Review of Carbon Review of Carbon TerraVault (CTV) Responses to EPA's Questions about Proposed Testing and Monitoring Activities at the A1-A2 Class VI Project

In January 2022, EPA provided questions to CTV (*blue, italic text*) about proposed injection and post-injection monitoring activities submitted with CTV's Class VI permit application (dated August 30, 2021) for the proposed Carbon TerraVault (CTV)-Elk Hills Class VI geologic sequestration (GS) project. CTV provided an updated Testing and Monitoring Plan and PISC and Site Closure Plan to EPA on March 31, 2022. EPA's evaluation of how the updated plans address its questions is presented in **red** below. CTV responded to EPA's request on November 4, 2022. EPA's evaluation of the response is in **green text**. Requests for revisions and additional information are presented in **green, bold, and italic** below.

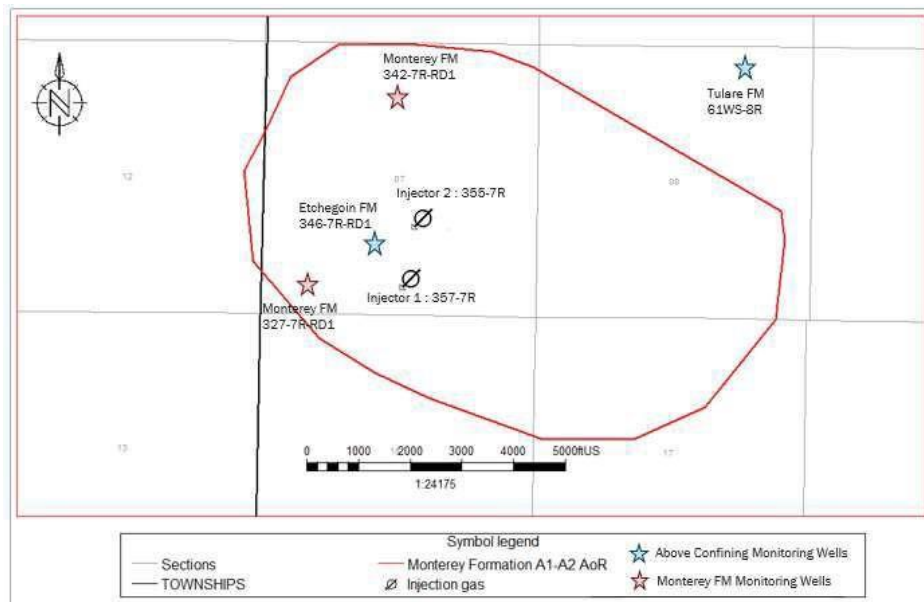
- *Please confirm that at least one external MIT will be performed on the monitoring wells.*
- *Please include quarterly sampling in the A3-A11 wells on Table 4 of the PISC and Site Closure Plan to provide consistency/continuity of injection-phase monitoring.*
